Subject	2-32 SMITH STREET, SUMMER HILL, PROJECT APPLICATION
File Ref	FM APRIL 2013
Prepared by	Con Colot - Senior Strategic Planner & Projects
Reasons	Provide the Department of Planning & Infrastructure with comments on the Project Application for Stage 1 at the Flour Mills site, 2-32 Smith Street Summer Hill.
Objective	For Council to determine its response to the project plan application.

1.0 Purpose of Report

Diagram 1 - Extract of Landscape Drawing (DA 1000) with Council officer explanatory commentary noted on the diagram.

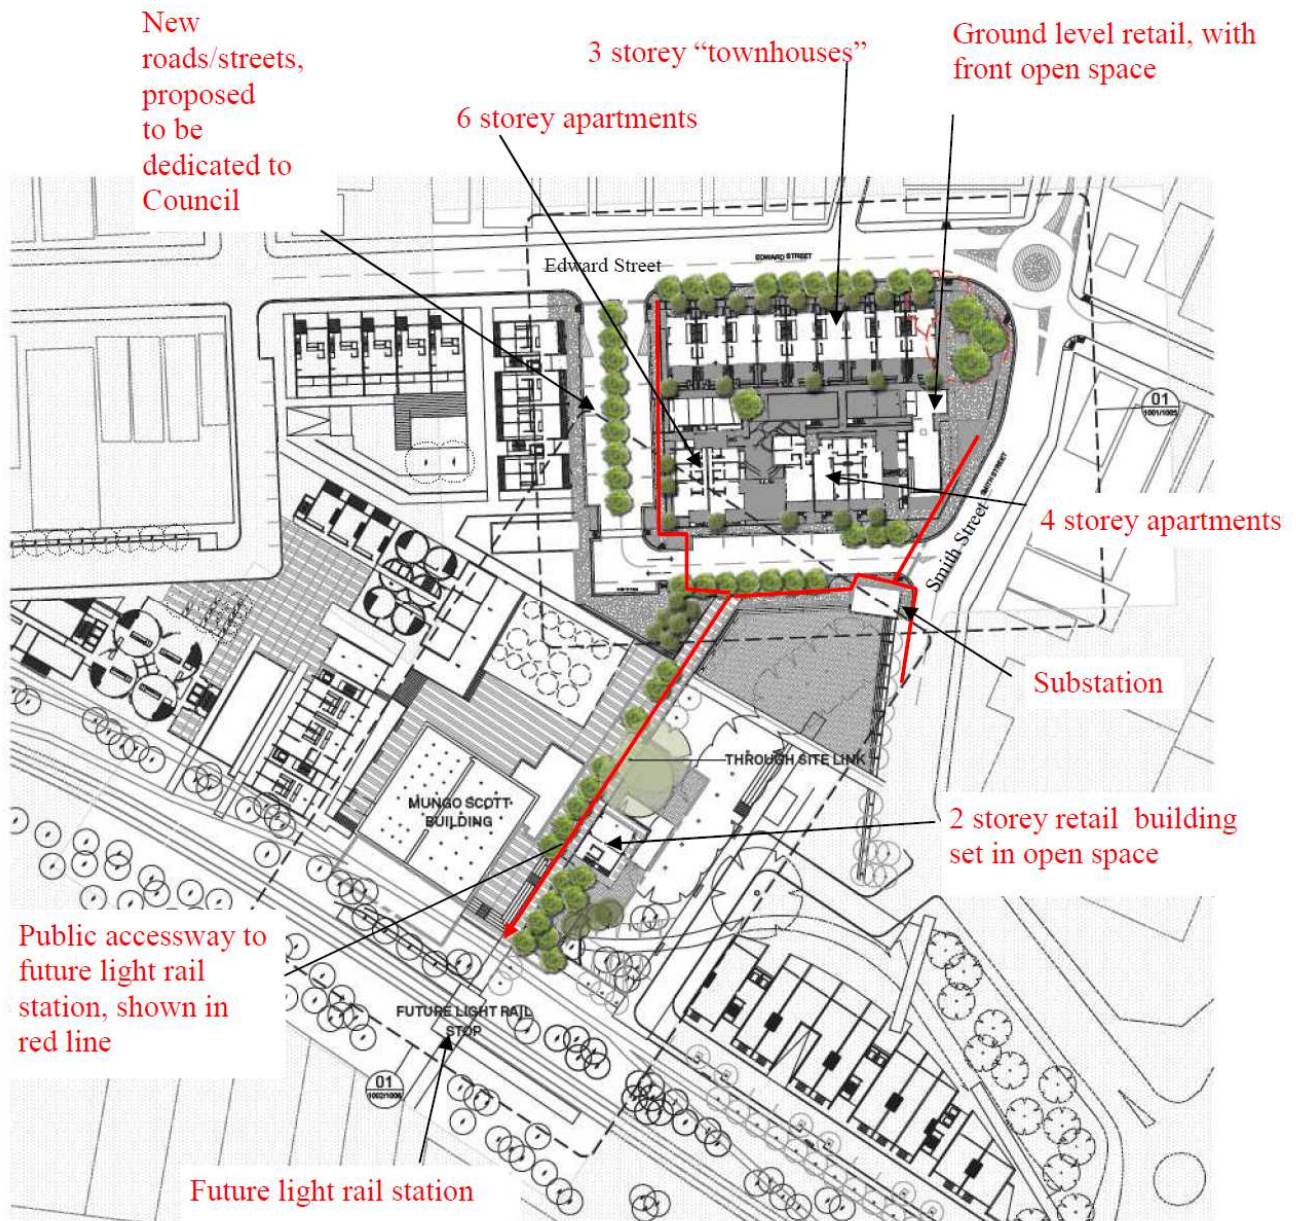
See **Diagram 1** of this report for a plan location description of the above.

Diagram 2 Extract of Indicative Subdivision Plan (DA 012) with Council officer explanatory commentary noted on diagram.

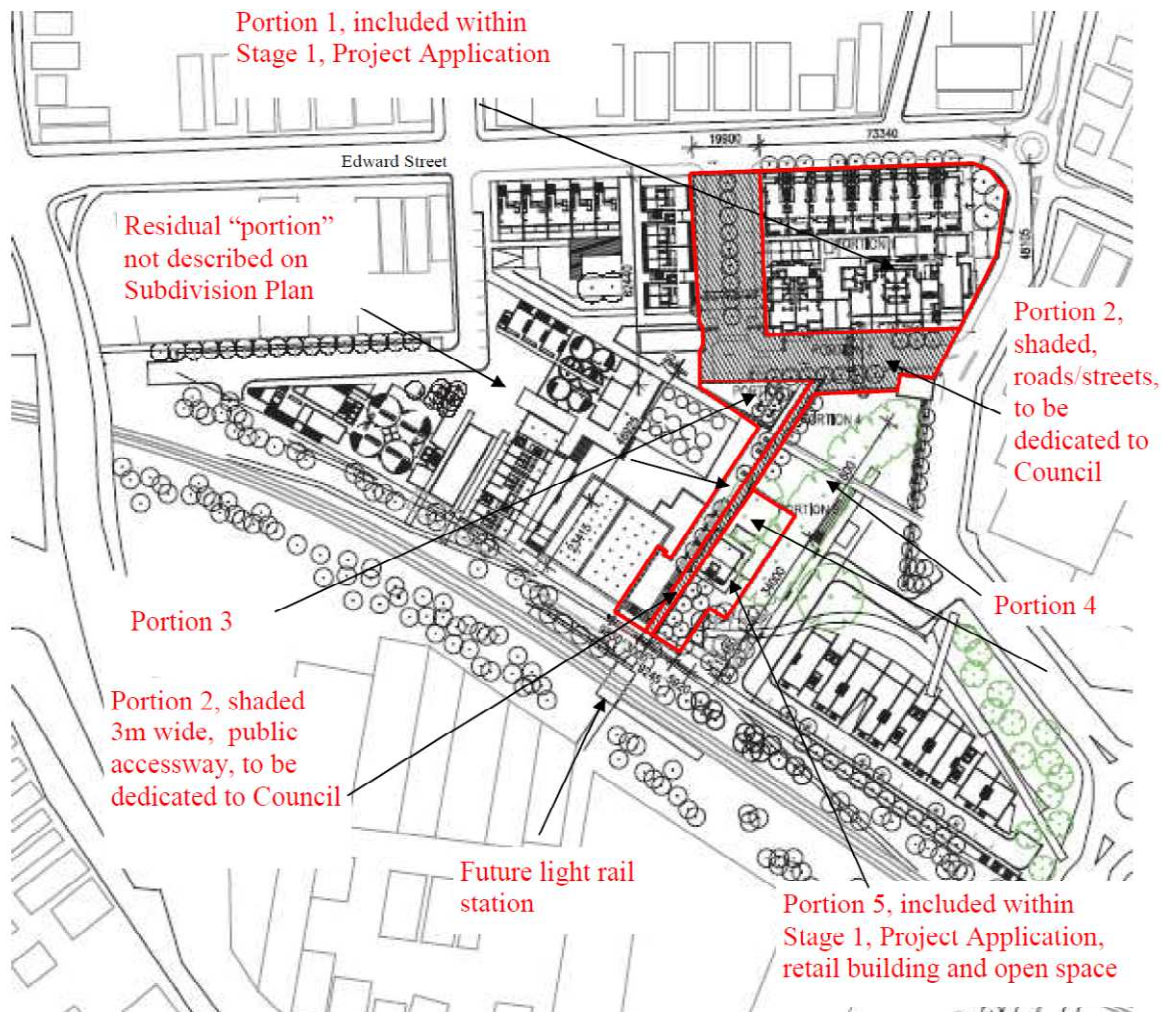
The development is proposed to be staged in 6 parts, as shown on the 'Indicative Subdivision Plan' (DA -012), and as shown in **Diagram 2** of this report.

As previously brought to the attention of the Department, once land subdivision occurs, each allotment will potentially be able to be sold to individual owners and separately developed. This creates uncertainty about how each development stage will address the complexities and share the burden of complying with the numerous Concept Plan conditions, and for example provide the various infrastructure works located on other parts of the site or external to the site. Another issue is whether different land owners will be willing to comply with the Concept Plan approval conditions, or instead seek amendment of the conditions.

In order to provide certainty to the Concept Plan approval conditions 23, 24, 25 and 26 (see extract under **Diagram 2**) which require publicly accessible open space and a public access way to the Light Rail station, a condition should be placed on any Project Application approval reflecting the Concept Plan conditions 23, 24, 25 and 26 and requiring that the relevant 'restriction as to user' be placed on all the relevant land titles.

There is a proposed pedestrian accessway, located within the Portion 2 allotment from Smith Street to the RailCorp land and the Light Rail station - see **Diagram 2**. This is a major public benefit feature of the Concept Plan approval, and will also provide a link to a future GreenWay corridor and also a link to Hudson Street in Lewisham. This is given special importance in the Environmental Assessment, with references being made to the Metro Strategy and the pathway's regional importance.

The applicant's drawings (e.g. DA 1002 in **Attachment 3**) show the accessway between the internal street, up to the boundary with the RailCorp land (adjacent the future light rail station), as being 8 m wide. This is because it naturally contains various mandatory fixtures in order for it function properly as a public space. However, the subdivision plan shows a dedication to Council of only 3m in width, being the part containing the concrete pedestrian pathway part of the access way, and being the part that will be publicly accessible as 'public land'. The remaining parts of the 'outer wings' of the accessway, based on the proposed subdivision plan, would remain in private land ownership and be subject to the preferences and decisions of future land owners.

Given the above, the dedication of the public accessway to Council, between the internal street up to the boundary of the site near the Light Rail station, should contain the entire 8 m width as shown on the applicant's landscape and site plan drawings. A condition should be placed any Project Plan approval to confirm this requirement.

Diagram 3 - Extract from 'Flooding, Stormwater and Utilities report' showing extent of flooding on the site and surrounding areas with Council officer explanatory commentary in red.

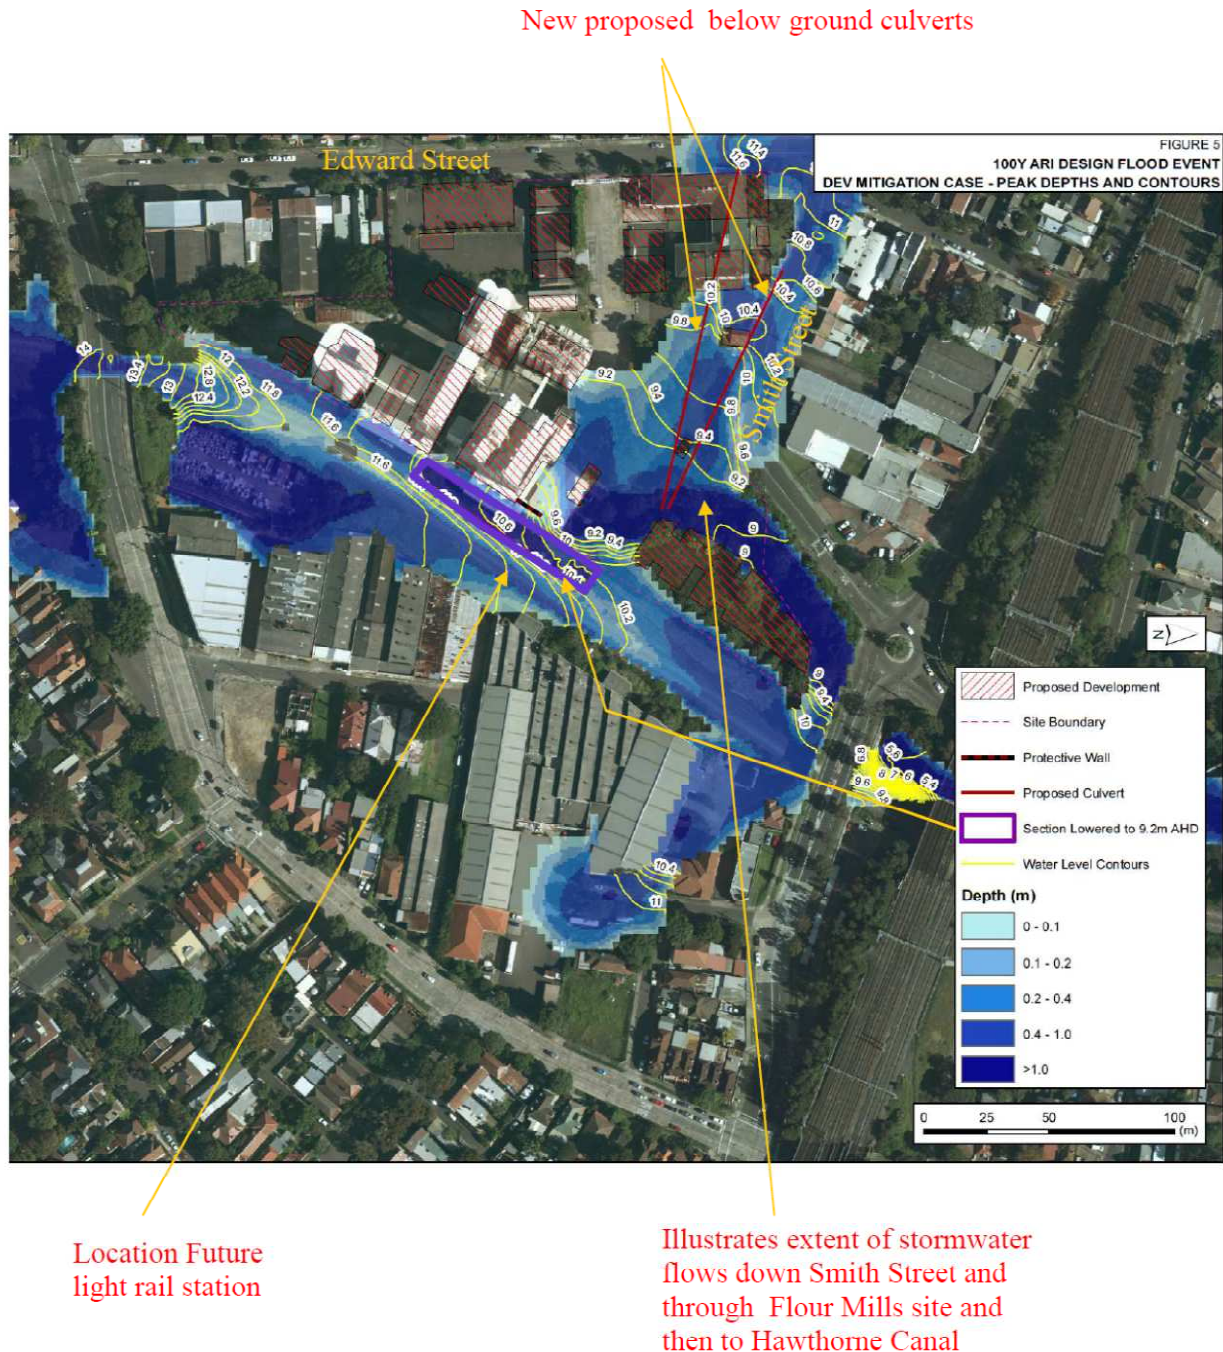
There is a large stormwater catchment area which flows down Smith Street and some of this flow is picked up by a large underground pipe from the Flour Mills site to the Hawthorne Canal - **see Diagram 3** of this report.

Some local stormwater which flows down Smith Street will be diverted around the Stage 1 site potentially down the access pathway link or within the 'Portion 4' allotment. There are various underground pipes (culverts) proposed to deal with this flow.

Council's engineers advise it is not possible at this point in time to determine whether the proposed stormwater disposal system is adequate based on the submitted documentation. Consultation between Ashfield Council would be required with Sydney Water on this matter. Additional engineering staff resources, or an independent review by consultants, would be required to analyse and check the various and numerous complexities associated with the proposed stormwater mitigation work, given the large upstream area catchment which might otherwise be adversely affected. Easements would also need to be placed on the site, which would affect the proposed subdivision plan.
